Subject: **Response to Portion of NRC RAI Letter No. 290 Related to ESBWR Design Certification Application - DCD Tier 2 Section 3.7 – Seismic Design; RAI Number 3.7-63 S02 Revision 1**

**Response to NRC RAI Letter No. 290  
Related to ESBWR Design Certification Application<sup>1</sup>**

**DCD Tier 2 Section 3.7 – Seismic Design**

**RAI Number 3.7-63 S02 (Revision 1)**

Figure 3.7-63(18) FRS (Effect of Structure-Structure Interaction) – FWS Basemat Y

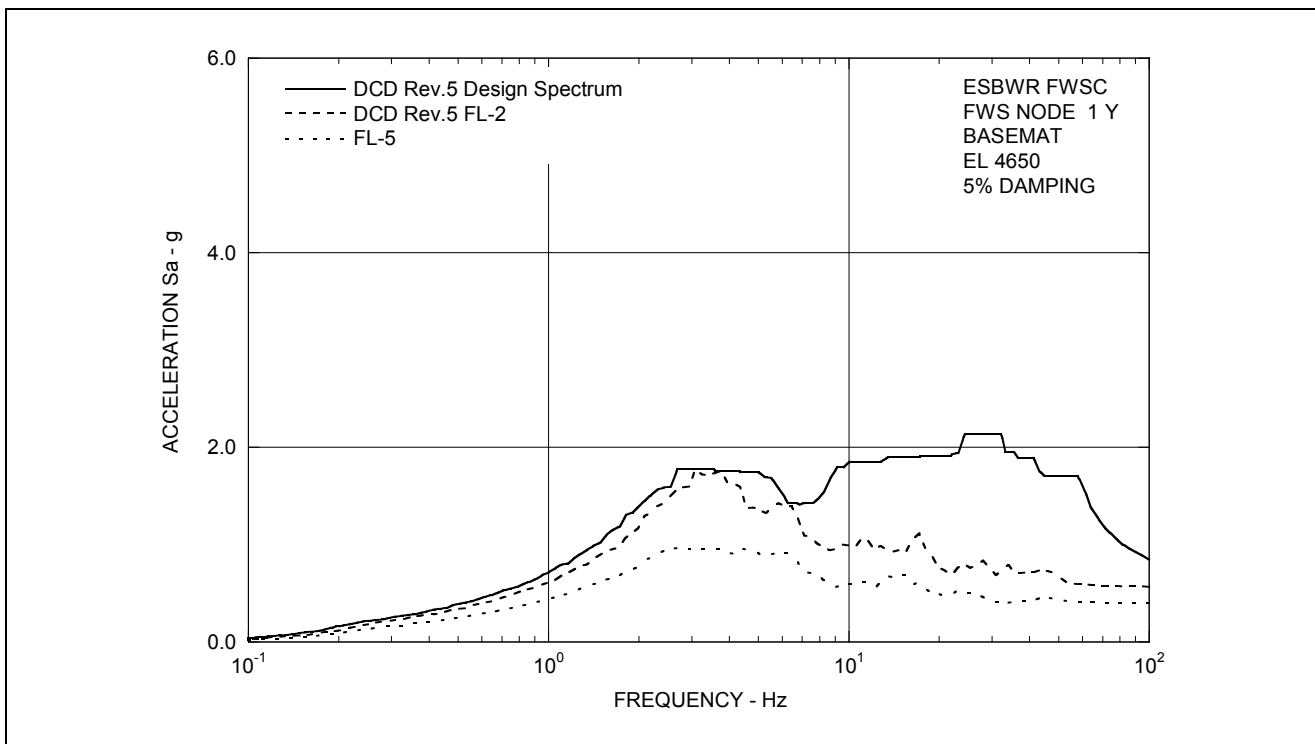
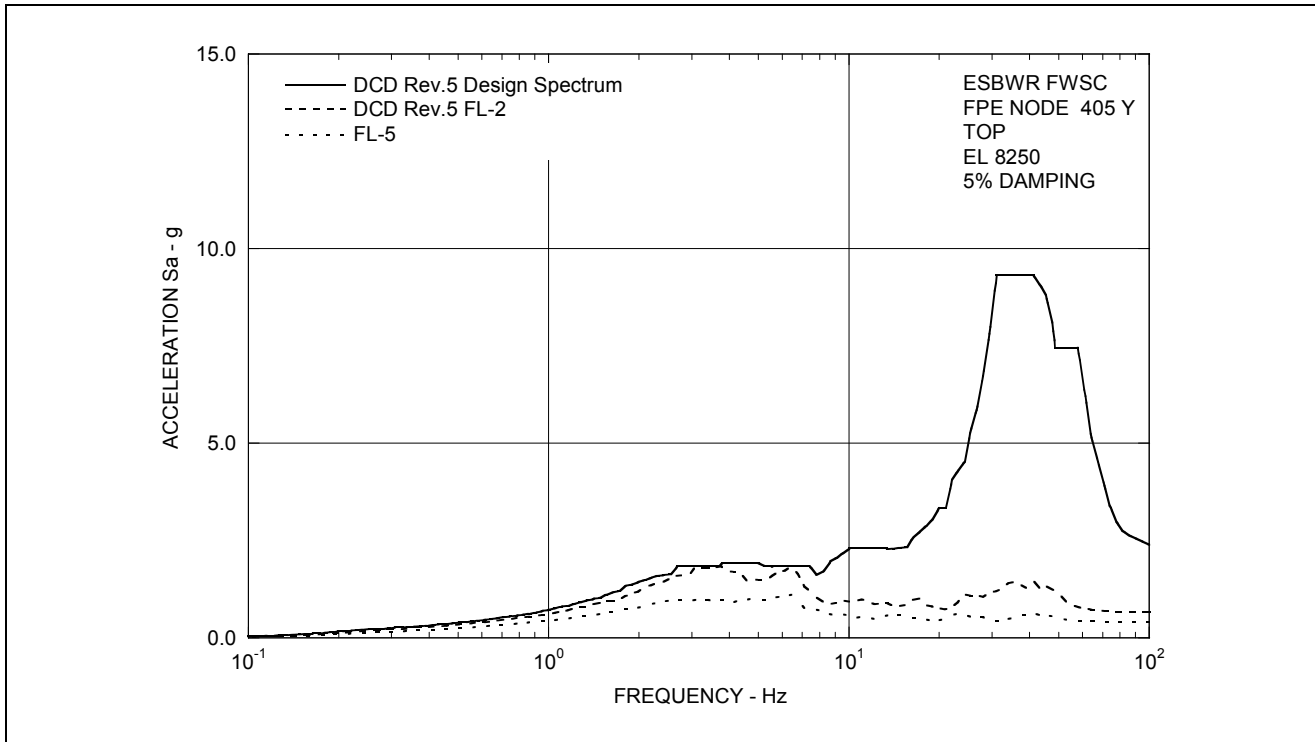
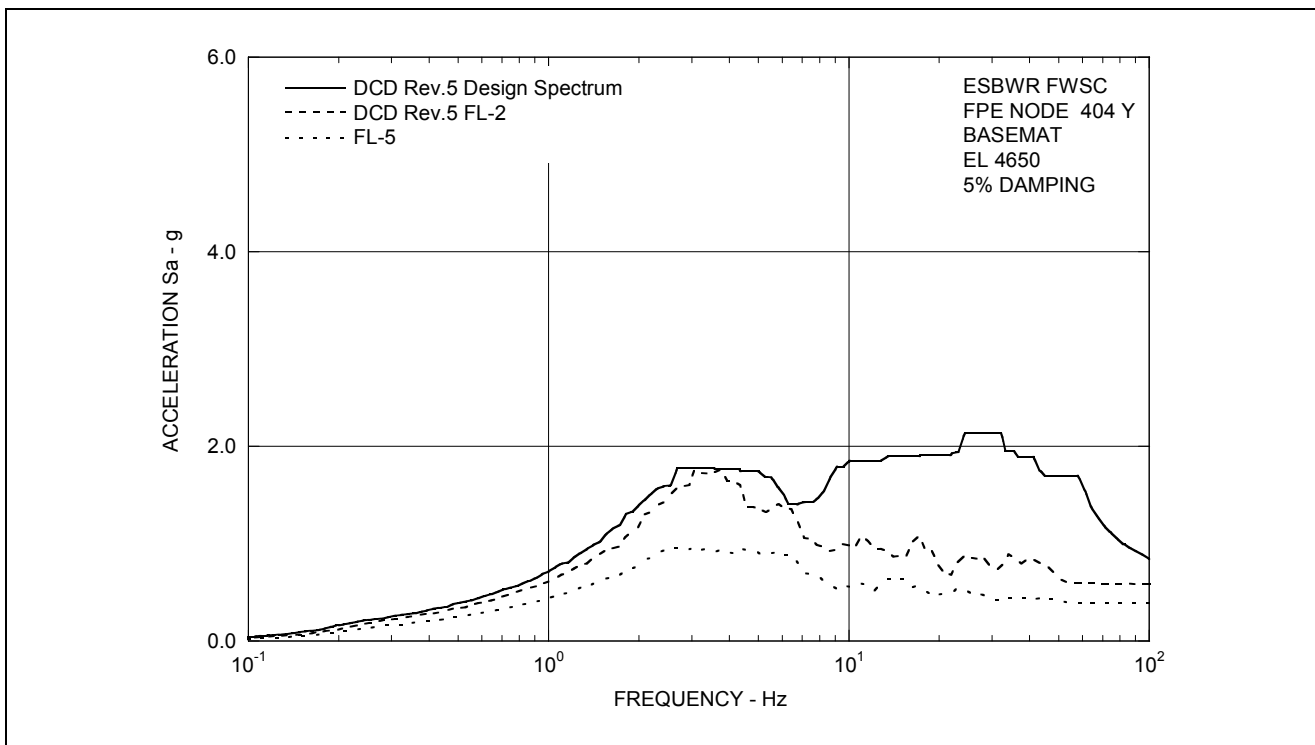
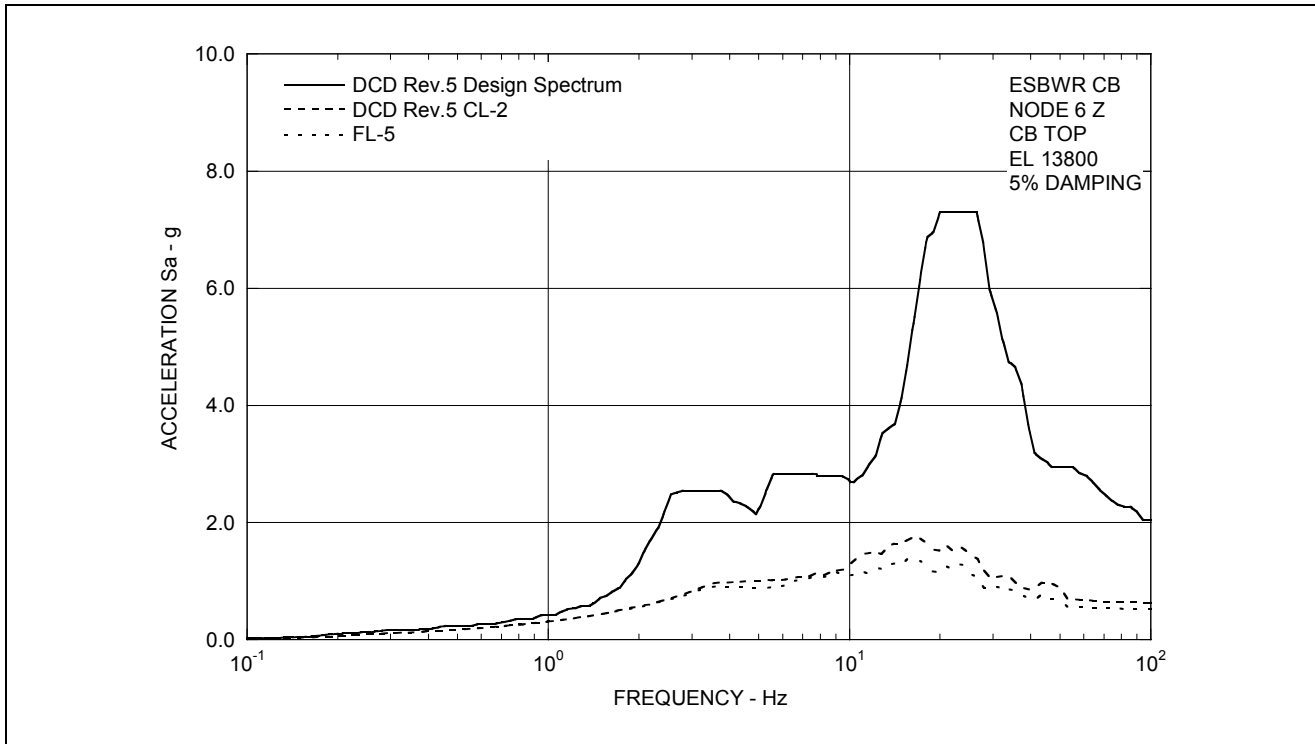
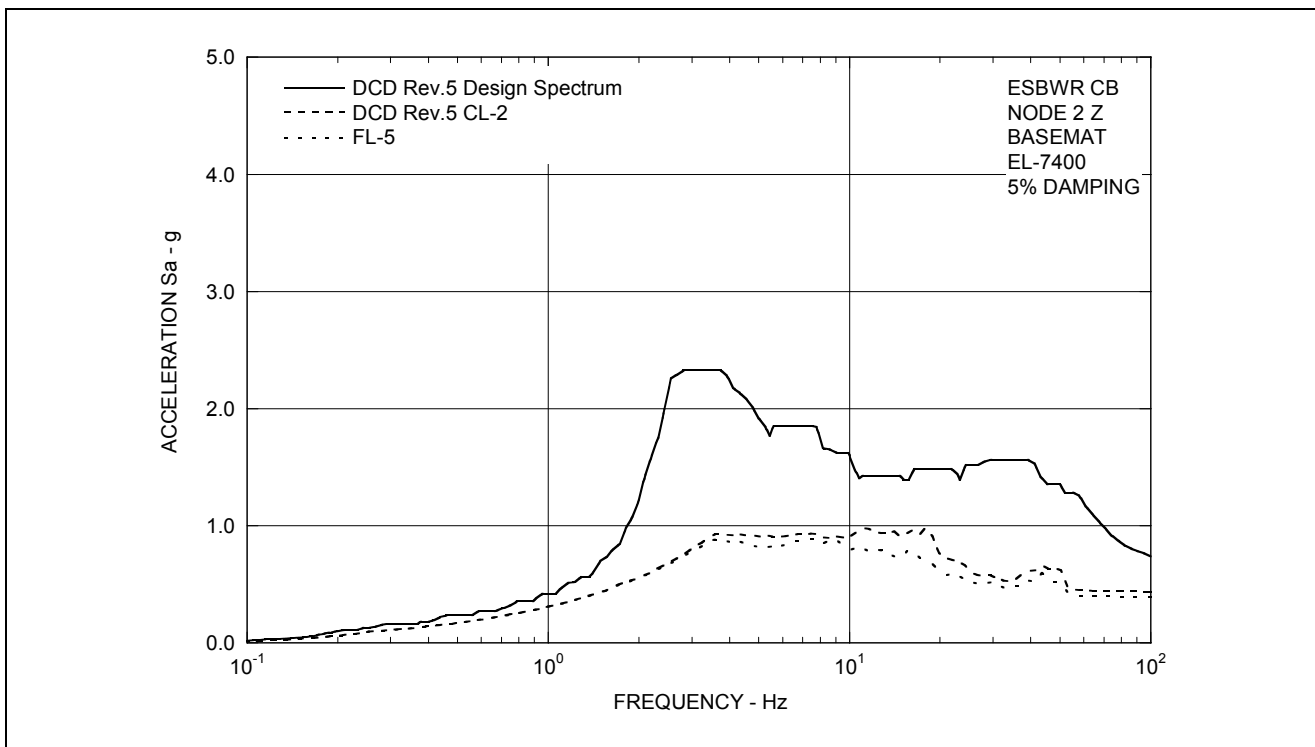
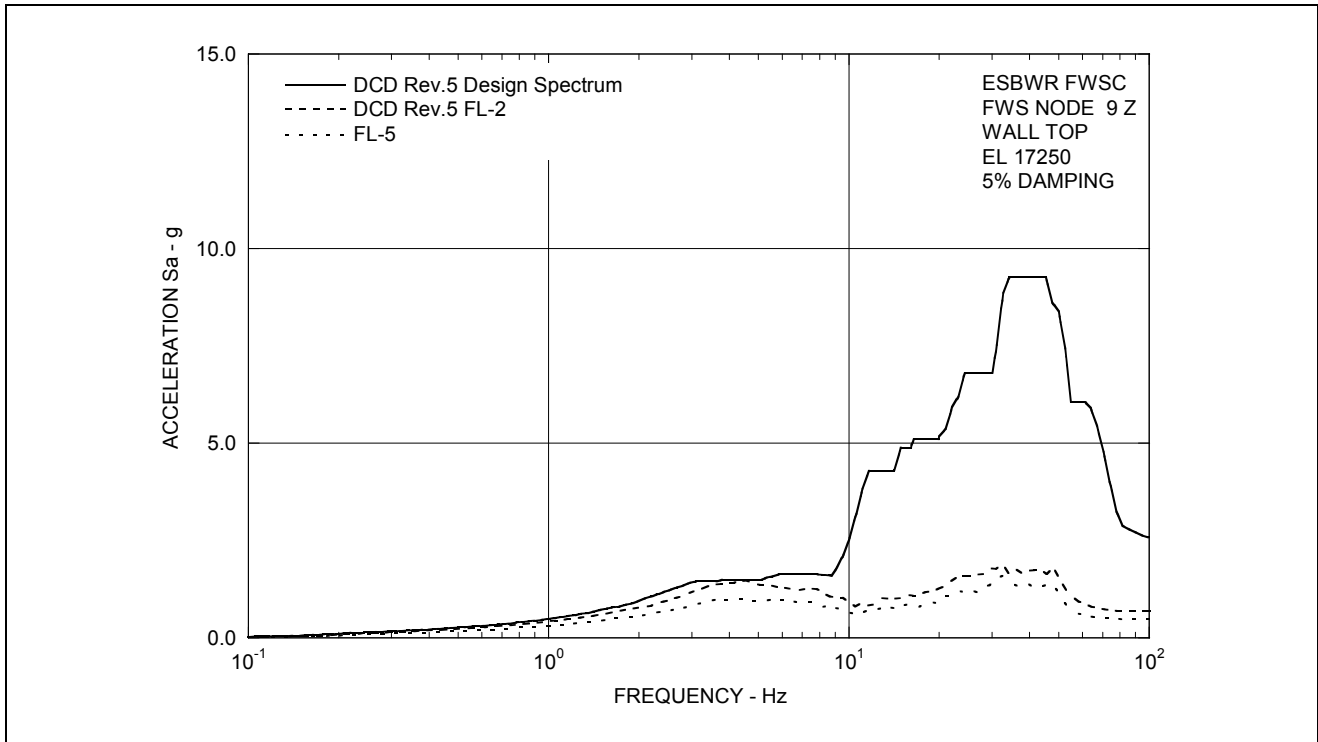
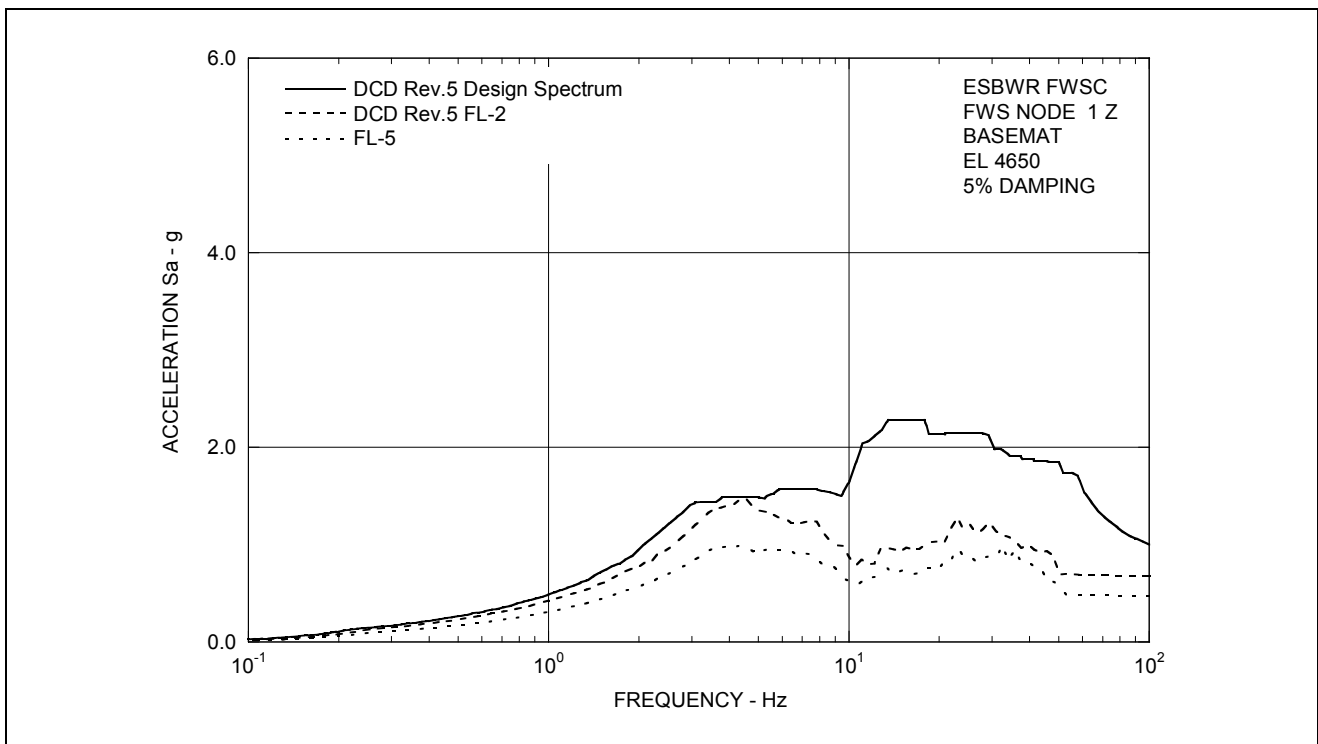
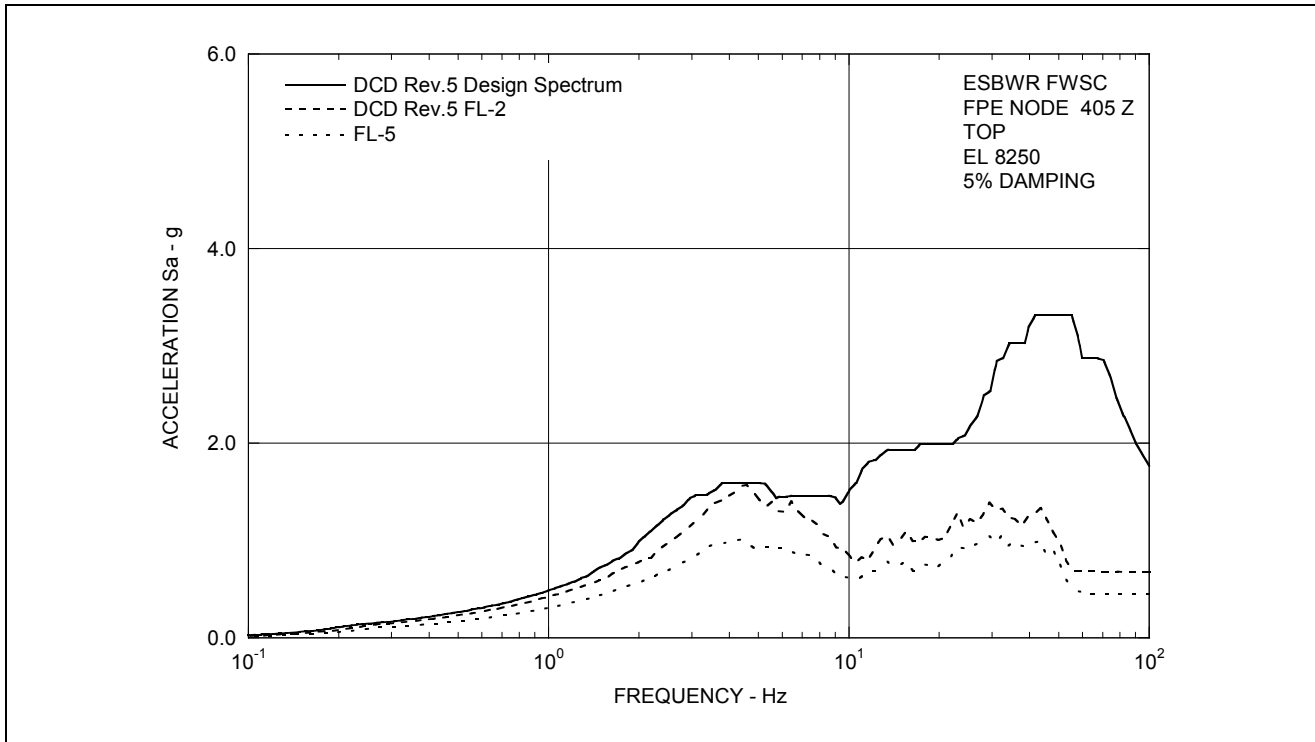
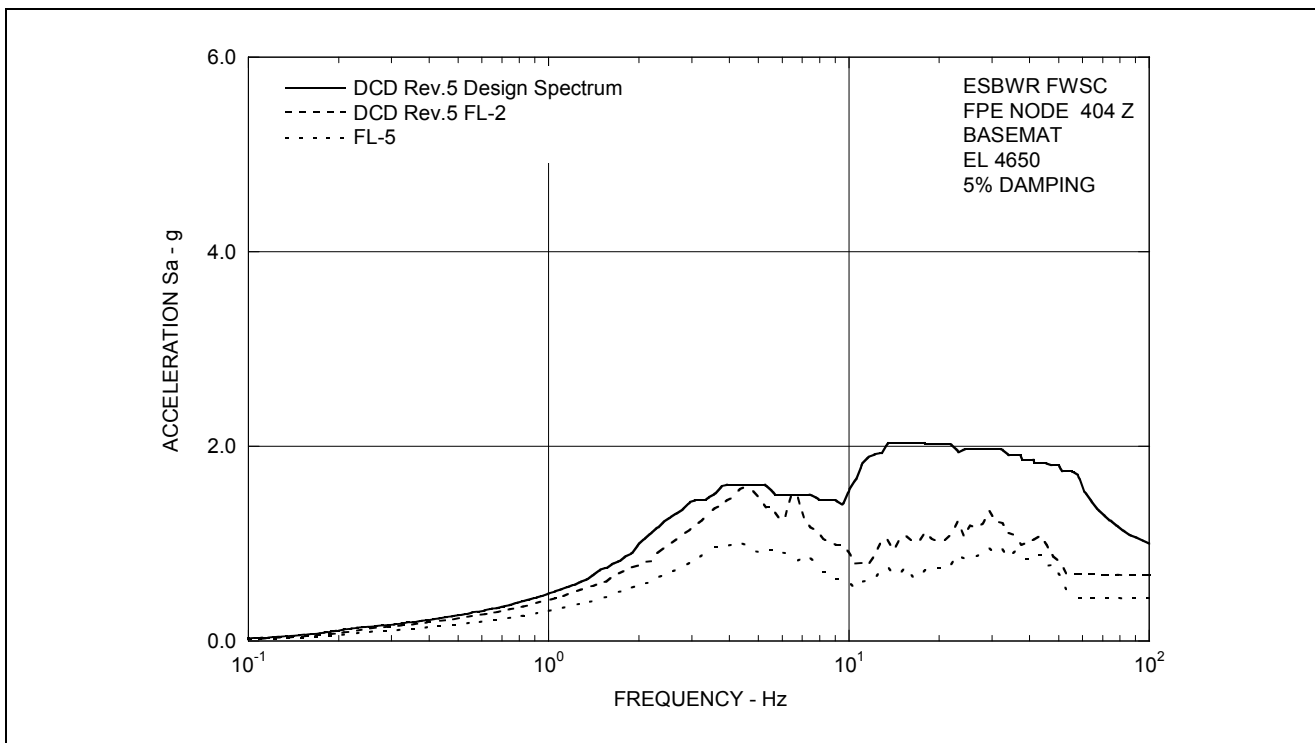
*During a teleconference on 12/10/2008 related to RAI 3.7-63 S01, the staff discussed with GEH how the potential for structure-soil-structure interaction was addressed in its evaluation of the FWSC. GEH indicated that it had not conducted any specific analysis due to the appreciable distance between the closest building (CB) and the FWSC. The staff considers that a quantitative evaluation of this potential effect is needed to address this issue. The following two approaches may be considered:*

Figures 3.7-63(9) through 3.7-63(26) show comparisons of floor response spectra (FRS) with the design envelope spectra at selected locations in the two structures. The FRS for the corresponding analysis Cases CL-2 and FL-2 without the structure-soil-structure interaction effect are also shown in the figures for comparison. It is confirmed from the results that the FRS with the structure-soil-structure interaction effect are bounded by the DCD Revision 5 design envelope spectra in all frequency ranges. Consequently, it can be concluded that 1.35 times CSDRS is a conservative design input motion to the FWSC and can be compared with the site-specific FIRS directly without considering structure-soil-structure interaction effects in COL applications. DCD
